# DART SERVICE INSTRUCTION

TO AMEND INSTALLATION INSTRUCTIONS IIN-D117-762 REV. F OR LATER APPROVED REVISION AND  
INSTRUCTIONS FOR CONTINUED AIRWORTHINESS ICA-D117-762 REV. 5 OR LATER APPROVED REVISION

A	NEW ISSUE		SAD	21.07.16		
REV.	DESCRIPTION		BY	DATE		
DESIGN	SAD	DART AEROSPACE USA, INC. HILLSBORO, OR				
DRAWN	SAD	DRAWING NO. DSI 9857				
CHECKED	HE	REV. A SHEET 1 OF 3				
MFG. APPR.	SAD	TITLE				
APPROVED	CP	ANTI - ROTATION KIT				
DE APPR.	DS <i>[Signature]</i>	NTS				
DATE	21.07.16	COPYRIGHT © 2021 BY DART AEROSPACE USA, INC. THIS DOCUMENT IS PRIVATE AND CONFIDENTIAL AND IS SUPPLIED ON THE EXPRESS CONDITION THAT IT IS NOT TO BE USED FOR ANY PURPOSE OR COPIED OR COMMUNICATED TO ANY OTHER PERSON WITHOUT WRITTEN PERMISSION FROM DART AEROSPACE USA, INC.

**FIGURE 1 - DRILLING DETAIL**

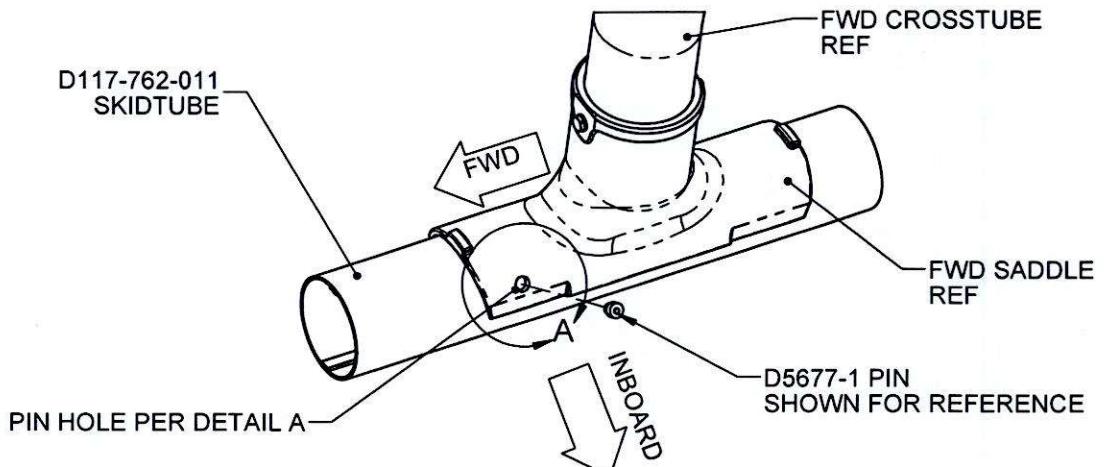
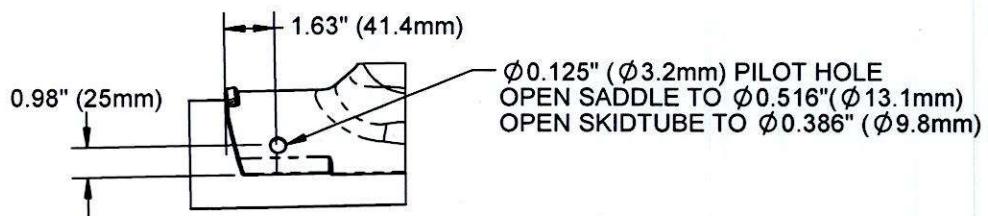
- 2.1 Pilot drill Ø0.125" (Ø3.2mm) through the forward saddle per Figure 1, Detail A of this Service Instruction.
- 2.2 Temporarily position and secure the fwd saddle onto the skidtube per Figure 1a of IIN-D117-762. Ensure the saddle is positioned correctly and that the skidtube will be vertical with weight on the landing gear. Transfer mark the pilot hole onto the skidtube, being careful not to damage the web inside the skidtube when drilling.

- 2.3 Remove skidtube and open the saddle hole to Ø0.516" (Ø13.1mm). Open the hole in the skidtube to Ø0.386" (Ø9.8mm). Deburr holes and touch up with chemical film (Alodine 1200) per MIL-DTL-5541.

**FIGURE 2 - D5677-1 PIN INSTALLATION**

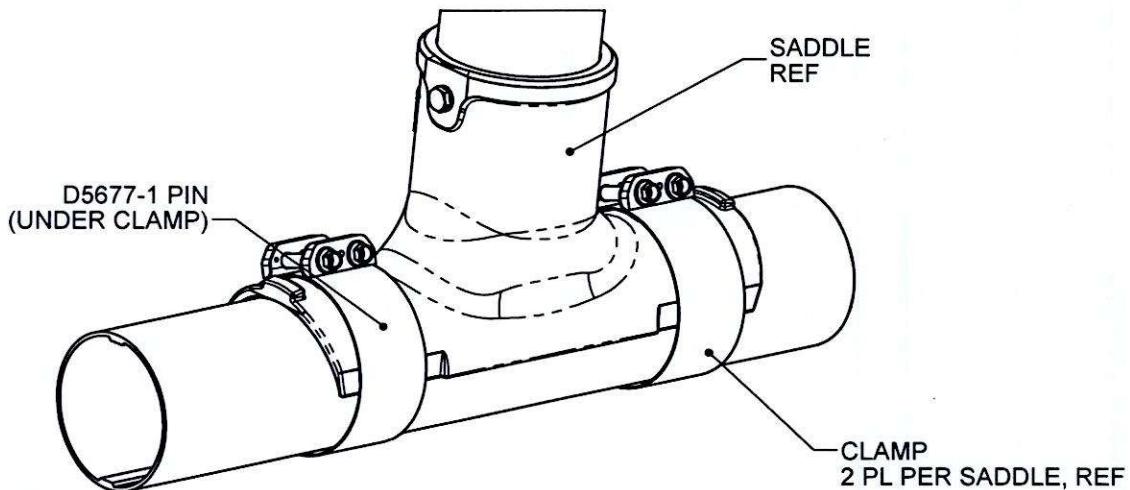
- 2.4 Continue the installation of the skidtube per Step 3.1.3 of IIN-D117-762 or Step 32.2.4 of ICA-D117-762. However, ensure the D5677-1 Pin is installed under the clamps as shown in Figure 1 & 2 of this Service Instruction. Seal the surface between the pin and the skidtube using a sealant per Section 2.0 of IIN-D117-762.

When re-installing the D117-762-011 Skidtube Installation per Section 32.2 of ICA-D117-762, ensure a D5677-1 Pin is installed under the clamps per Figure 1 & 2 of this Service Instruction. Seal the surface between the pin and the skidtube using a sealant per Section 2.0 of IIN-D117-762.
